Planning Approval Environmental Review Form

Assessment Name:	Additional minor works to Clarke Lane Heritage building
Prepared by:	Sydney Metro
Prepared for:	Sydney Metro and all relevant contractors
Assessment number	TfNSW 81
Type of assessment:	Assessment under EP&A Act 1979, Division 5.2.
Version:	Final (1.0)
Planning approval No. (where relevant):	SSI_7400
Date required:	July 2024
iCentral number	SM-24-0012927

Appendix A – Heritage Memo

Figure 3 – Pavement detail (provided by contractor)

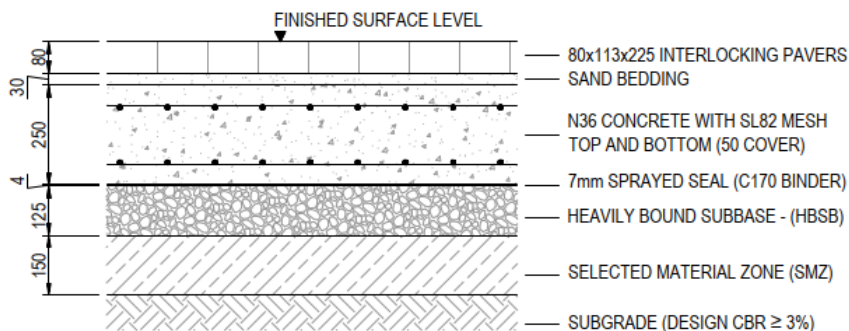
CNDC would think they would extend the 80mm of pavers with 30mm bedding sand up to the steps. That would require milling the existing concrete. Equipment used is likely to involve saw-cutters and a jack hammer. Refer to Figure 3.

This impact is consistent with the overall degree of impact approved for the project. It is recommended introduced material and finish must visually match the surrounding original fabric and finish.

Figure 4 – Proposed level adjustment

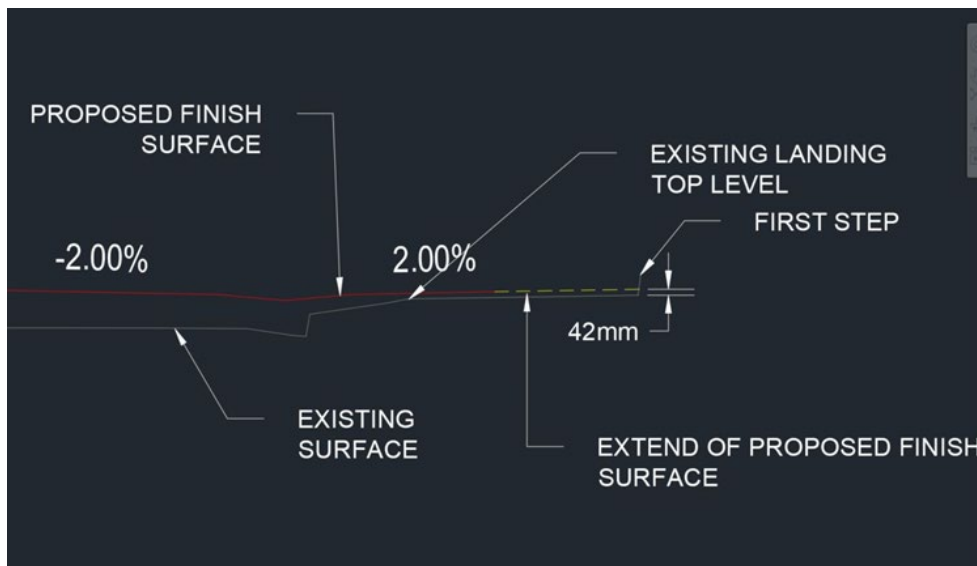
It is proposed to extend the footpath works within the site boundary limit, in order to provide smooth tie-in and crossfall away from the building (towards the road). This is shown in Figure 3.

The proposed tie in work is minor in nature and would only impact a very small part of the heritage listed building and would have a negligible impact on the heritage significance of the item. The proposed work would not visually compete with the item.
